#### ITEM 2 - KINGSWOOD ESTATES SUBDIVISION 2022

KPB File No.	2022-183
Plat Committee Meeting:	January 23, 2023
Applicant / Owner:	Melinda and William Nelson of Kenai, Alaska
Surveyor:	Gary Nelson / Ability Surveys
General Location:	Equestrian Avenue, Driftnetter Street, Buoy Avenue, and Seattle Slew Street,
	Kalifornsky

#### STAFF REPORT

KPB File 2022-183 T 05N R 11W SEC 30 Kalifornsky

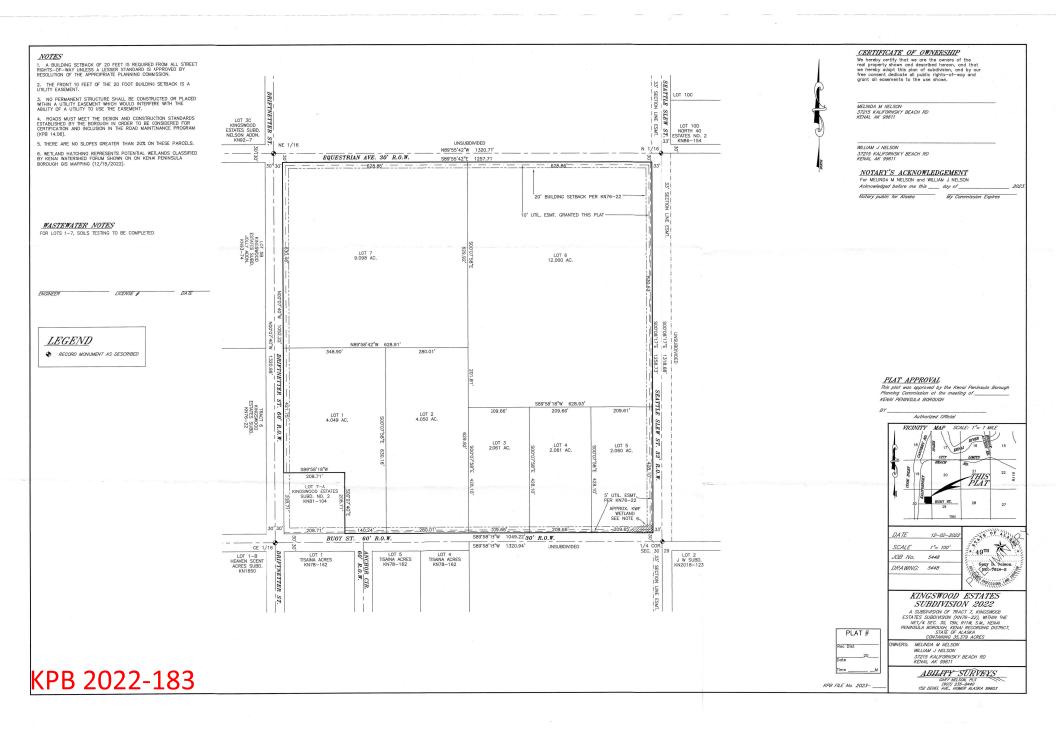
A section line easement is present along the eastern boundary. A parent plat dedicated a 33 foot right-of-way atop the easement. The plat does depict the section line easement continuing to the north and south as those dedications have not occurred at this time. A 33 foot section line easement is being shown adjacent within an unsubdivided property. There is some question on the status of that easement and if the width being shown is correct. **Staff recommends** the surveyor verify the width of the easement with the State of Alaska.

<u>Site Investigation:</u> There are some low wet areas present within the southeast corner. The area is depicted and labeled to reference plat note 6. **Staff recommends** the wetlands remain depicted on the final plat and a wetland determination note be added.

<u>Utility Easements</u> Kingswood Estates Subdivision, Plat KN 76-22, granted a 5 foot clearing easement along the southern and eastern boundary of Tract 7. This easement is being shown to be carried over. **Staff recommends** the label be updated to state "5' <u>clearing</u> esmt..."

Remove the depiction of the setback and 5 foot utility easement within Lot 7-A as it is not part of this subdivision.

**Staff recommendation:** Include within the description "excepting therefrom, Lot 7A Kingswood Estates Subdivision No. 2. KN 81-104."

- C. The location, width, and name of existing or platted streets and public ways, railroad rights-of-way, and other important features such as section lines or political subdivisions or municipal corporation boundaries abutting the subdivision;
  - **Staff recommendation:** Correct Buoy Street to Buoy Avenue.
- G. The status of adjacent lands within 100 feet of the proposed subdivision boundary or the land status across from any dedicated rights-of-way that adjoin the propose subdivision boundary, including names of subdivisions, lot lines, block numbers, lot numbers, rights-of-way; or an indication that the adjacent land is not subdivided:
  - **Staff recommendation:** Adjust the label or add an additional label for the lots to the northeast as Lot 10C is the same plat as Lot 10D. Update the recording number for the lot to the southeast to 2018-102.

Platting Staff Comments: Soils reports will be required for lots less than 200,000 square feet. Lot 6 and Lot 7 are not required to have a report but may if owners wish to include. Provide appropriate plat notes with lot designations the note applies.

Staff recommendation: comply with 20.60.110. Provide recorded distances and source.

Plat note 4 may be removed as no new roads are being dedicated but may remain if desired. Plat note 5 may be removed. Correct plat note 6 as the word "on" is duplicated.
